MECKLENBURG COUNTY
DEPARTMENT OF ENVIRONMENTAL HEALTH

APPLICATION FOR SOIL INVESTIGATION

APPENDIX H
SITE EVALUATION

SITE INVESTIGATION REPORT
INDIVIDUAL SEPTIC TANK SYSTEM
WITH SUBSURFACE,
SOIL ABSORPTION,
EFFLUENT DISCHARGE

7) ACCURATELY DIAGRAM & DIMENSION LOT

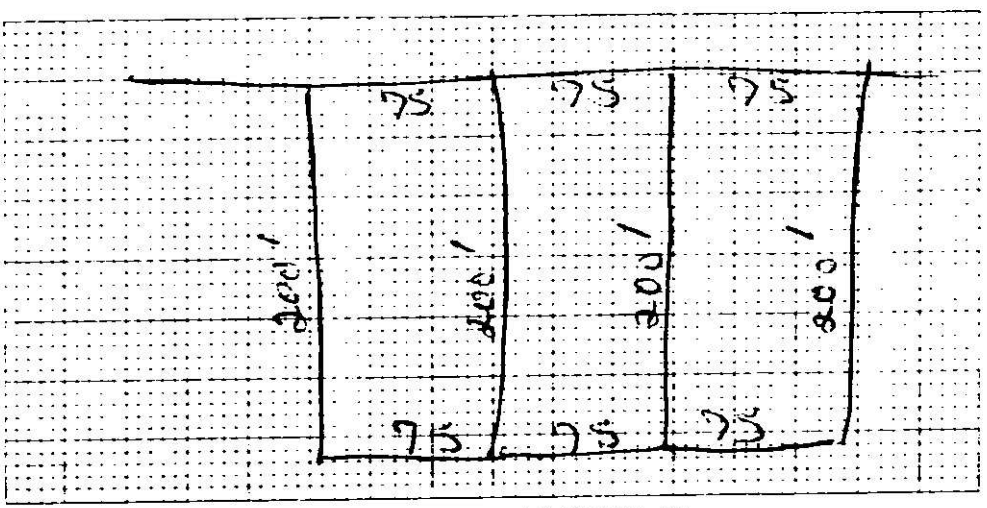
Inadequate area available for installation of ground absorption sewage disposal system in accordance with North Carolina Department of Human Resources specifications.

* See Diagram on Back (Include: Soil areas, property lines, roads, streams, gullies, wet areas, fill areas, wells, water bodies, slope patterns.

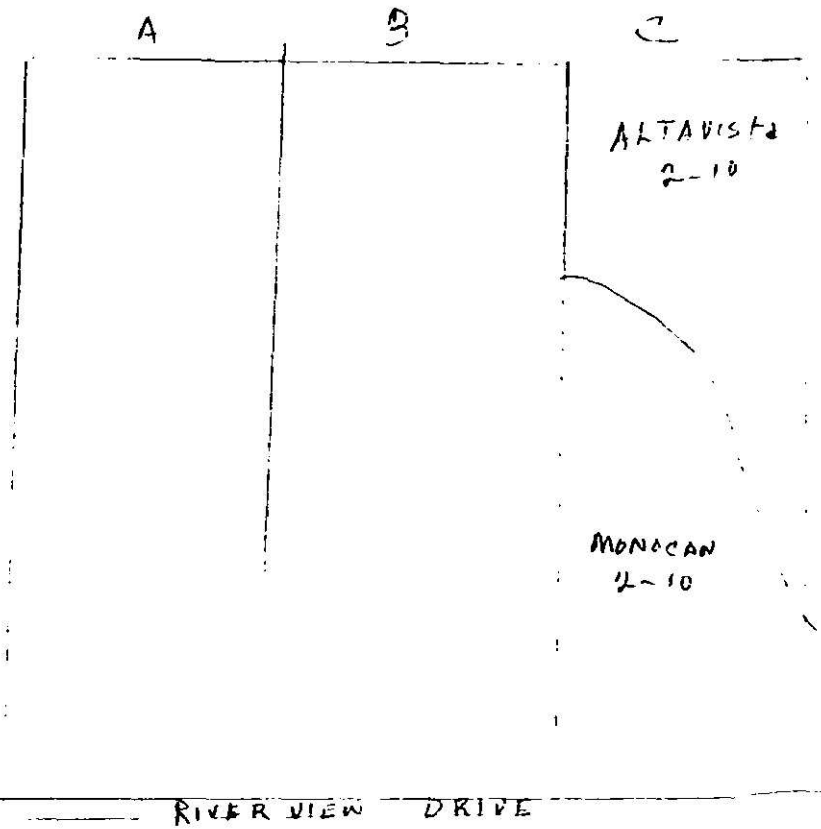
FACTORS	AREA 1	AREA 2	AREA 3	AREA 4
1. SLOPE (%)	S (PS) 2-10 U	S (PS) 2-10 U	S PS U	S PS U
2. SOIL TEXTURE (12-36 in.) (Sandy, loamy, clayey, Note 2:1, Clay)	S (PS) Loamy U	S (PS) Loamy U	S PS U	S PS U
3. SOIL STRUCTURE (12.36 in.) (Clayey Soils)	S (PS) Weak Blocky U	S (PS) Weak Blocky U	S PS U	S PS U
4. SOIL DEPTH (In.)	S PS > 48 (U)	S (PS) 48 U	S PS U	S PS U
5. RESTRICTIVE HORIZONS (In.) (Impervious Strata, Rock)	S PS Clay layer (U)	S (PS) None U	S PS U	S PS U
6. SOIL DRAINAGE/GROUNDWATER (External & Internal)	S PS High water Table (U)	S (PS) Adequate U	S PS U	S PS U
7. SOIL PERMEABILITY (Percolation Rate)	S PS Slow (U)	S (PS) Moderate U	S PS U	S PS U
8. OTHER (Specify) *	S PS U	S PS U	S PS U	S PS U
9. SITE CLASSIFICATION	Unsuitable	PROVISIONALLY Suitable		
SOIL SERIES	MONOCAN	Altavista

Recommendations/Comments: * Note limitation of size of lot
